CATAWBA NUCLEAR STATION, UNIT 1

AMENDMENT TO FACILITY OPERATING LICENSE

Amendment No. 134
License No. NPF-35

CATAWBA NUCLEAR STATION, UNIT 2

Table 3.9-1

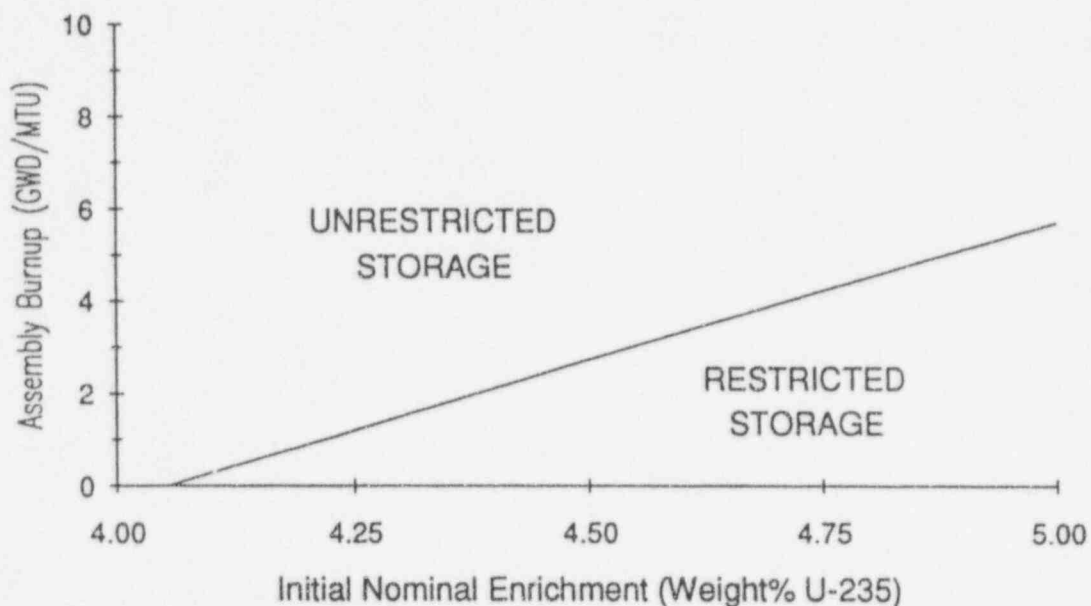
Minimum Qualifying Burnup Versus Initial Enrichment
for Unrestricted Storage

Initial Nominal Enrichment (Weight% U-235)	Assembly Burnup (GWD/MTU)
4.05 (or less)	0
4.50	2.73
5.00	5.67

Fuel which differs from those designs used to determine the requirements of Table 3.9-1 may be qualified for Unrestricted storage by means of an analysis using NRC approved methodology to assure that k_{eff} is less than or equal to 0.95.

Likewise, previously unanalyzed fuel up to 5.0 weight% U-235 may be qualified for Restricted storage by means of an analysis using NRC approved methodology to assure that k_{eff} is less than or equal to 0.95.

Table 3.9-2

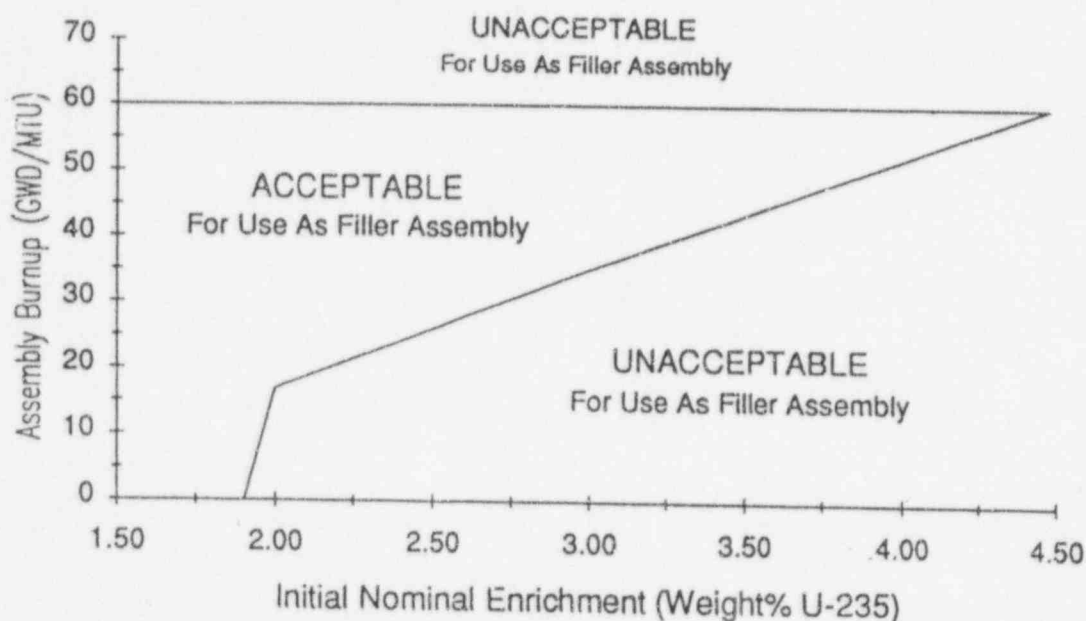
Minimum Qualifying Burnup Versus Initial Enrichment
for Filler Assemblies

<u>Initial Nominal Enrichment (Weight% U-235)</u>	<u>Assembly Burnup (GWD/MTU)</u>
1.90 (or less)	0
2.00	16.83
2.50	26.05
3.00	35.11
3.50	43.48
4.00	51.99
4.48	60.00

Fuel which differs from those designs used to determine the requirements of Table 3.9-2 may be qualified for use as a Filler Assembly by means of an analysis using NRC approved methodology to assure that k_{eff} is less than or equal to 0.95.

Figure 3.9-1

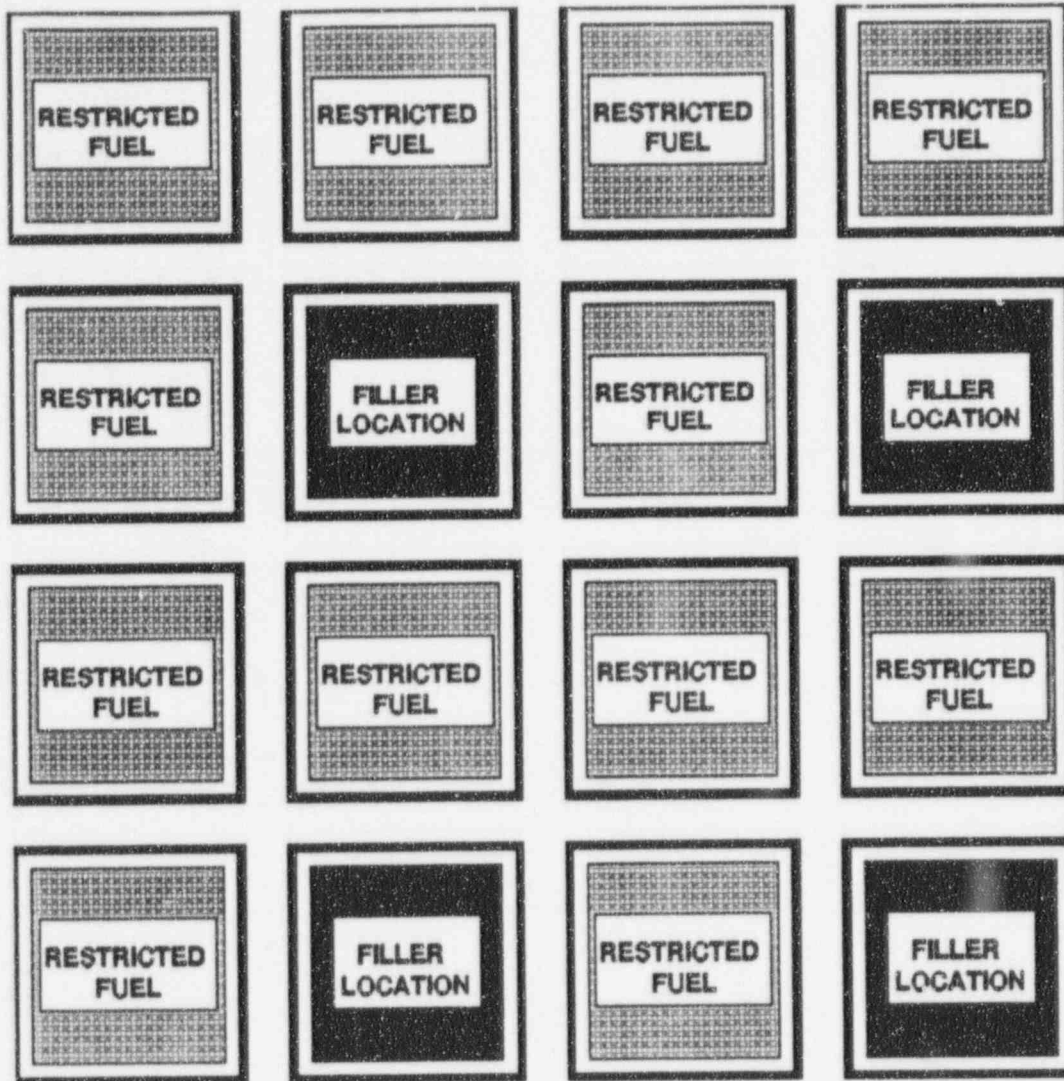
Required 3 out of 4 Loading Pattern
for Restricted Storage

Restricted Fuel:

Fuel defined for Restricted Storage in Table 3.9-1. (Fuel defined for Unrestricted Storage in Table 3.9-1, or non-fuel components, or an empty location may be placed in restricted fuel locations as needed)

Filler Location:

Either fuel which meets the minimum burnup requirements of Table 3.9-2, or an empty cell.

Boundary Condition:

Any row bounded by an Unrestricted Storage Area shall contain a combination of restricted fuel assemblies and filler locations arranged such that no restricted fuel assemblies are adjacent to each other.

Example: In the figure above, row 1 or column 1 can not be adjacent to an Unrestricted Storage Area, but row 4 or column 4 can be.
